SERVICE BULLETIN

APPLICABILITY: 2019-20MY Forester
2020MY Outback
2019-20MY Ascent

NUMBER: 12-300-20R

SUBJECT: Power Rear Gate (PRG) Switch Trim- Design Change

Trim Cover

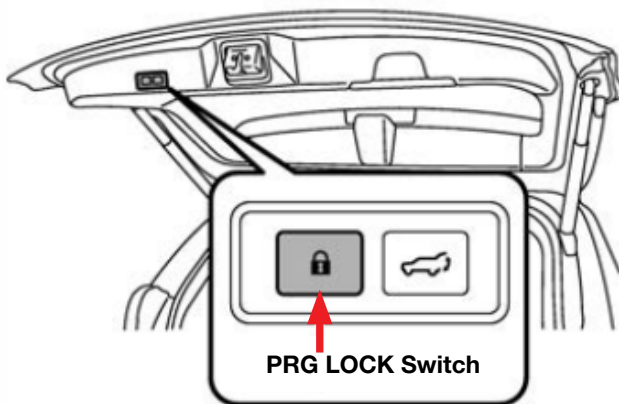
This bulletin announces design changes made to the trim cover for the rear gate PRG control switches located on the bottom of the rear gate inner trim panel as shown below. In some cases, if the buttons are pressed in a certain way, they may become stuck below the surface of the switch cover and not function properly. Changes were made to enhance the rigidity of the part along with increasing the thickness of the locking tabs.

Here, the **LOCK** button is shown stuck below the surface of the switch trim cover.

The part number for the new “CAP-TRIM PANEL,REAR GATE” is: **94381SJ011VH**.
